Development Review Comments

PAM2024-00151

2101 Gaither Road

PRE-APPLICATION SITE PLAN
PRE-APPLICATION MEETING
PARK PLAZA
ROCKVILLE (4th) ELECTION DISTRICT, MONTGOMERY COUNTY, MARYLAND

Park Plaza Study Intersections

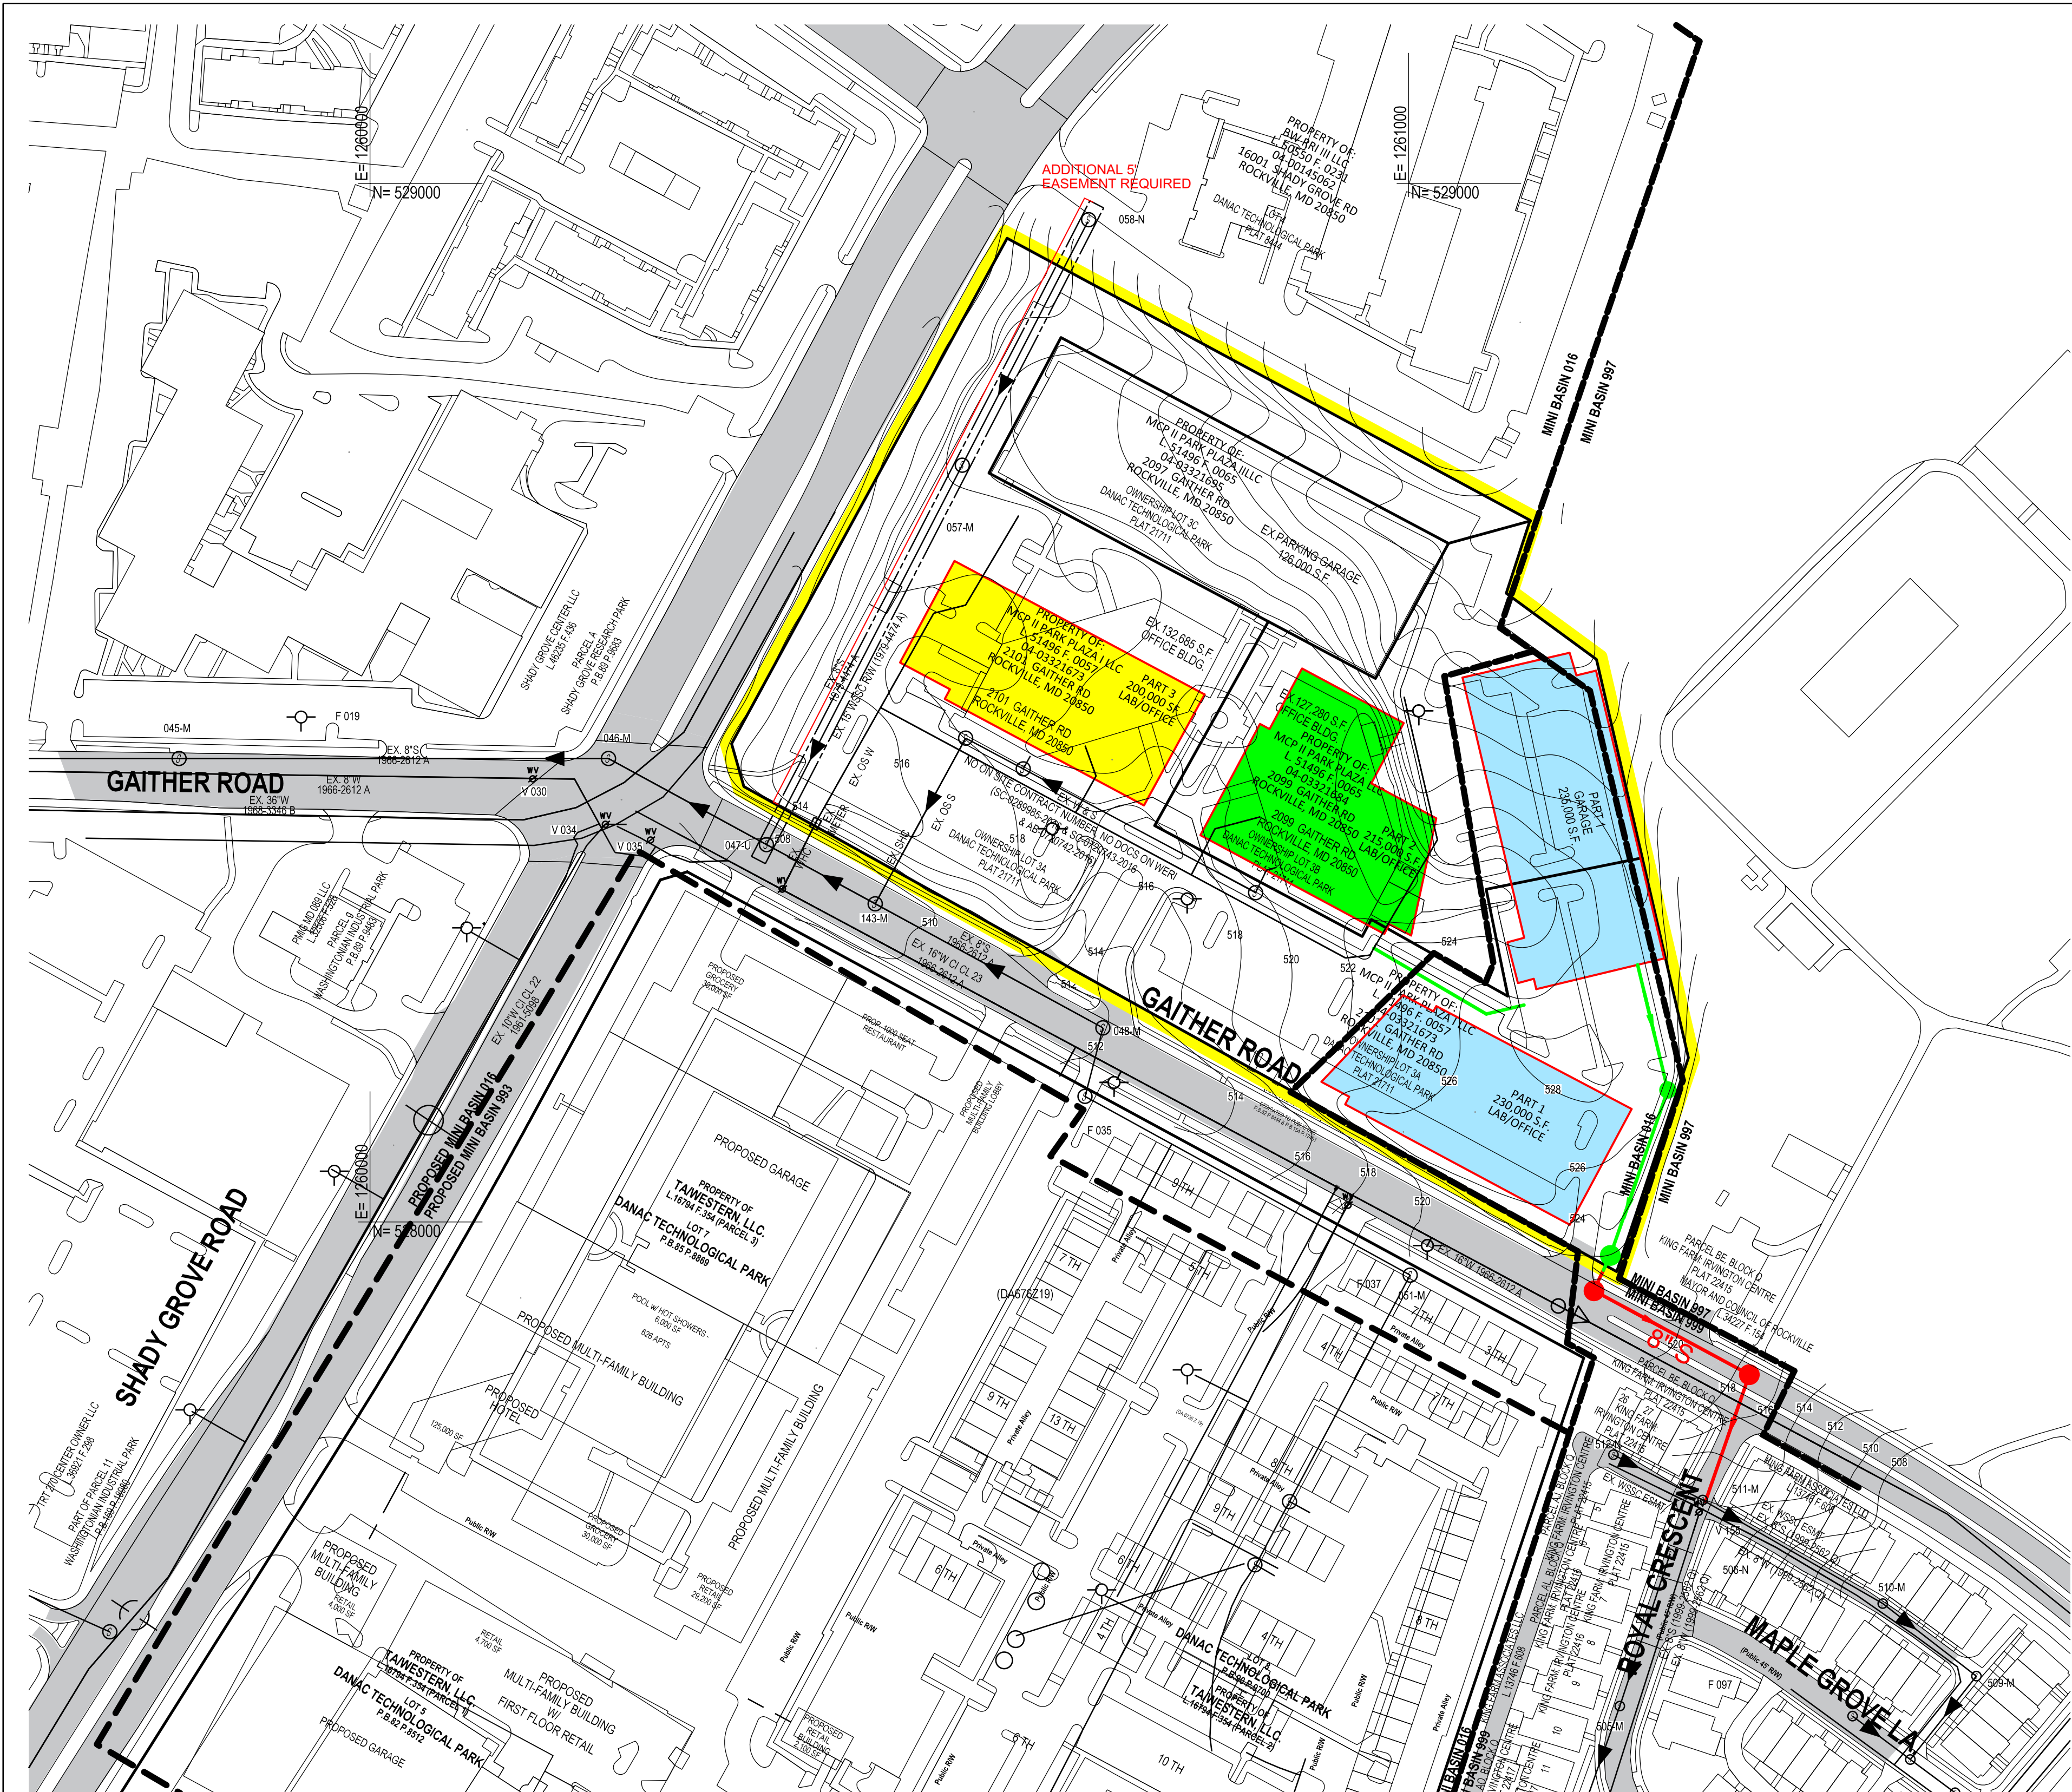
Since shown intersections 7 (Gaither and north site access) and 8 (Gaither and south site access) are intersections of existing site access driveways, please make sure the list of study intersections also include the following two additional intersections:

- ☐ The intersection of MD 355 with Shady Grove, and
- ☐ The intersection of Gaither Road with King Farm

BLUE PLAINS SERVICE AREA
MUDDY BRANCH DRAINAGE BASIN / MINI BASIN 16-999
HYDRAULIC PLANNING ANALYSIS
PARK PLAZA

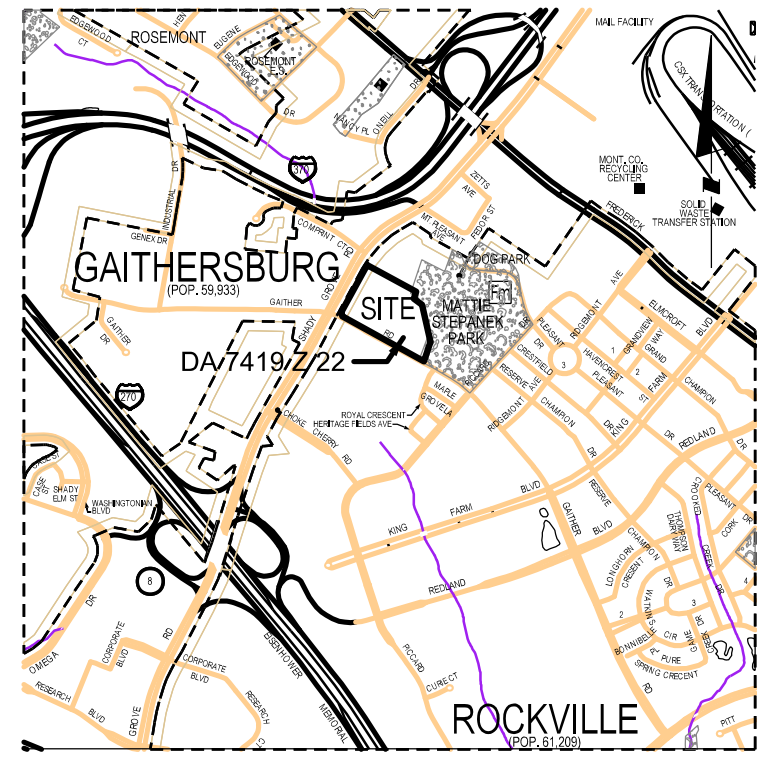
Additional easement is required to adequately maintain an existing main. The additional easement must be provided at no cost to WSSC. Provide five feet of additional easement width alongside the existing 15-foot easement that crosses this property as shown on the attached sketch.
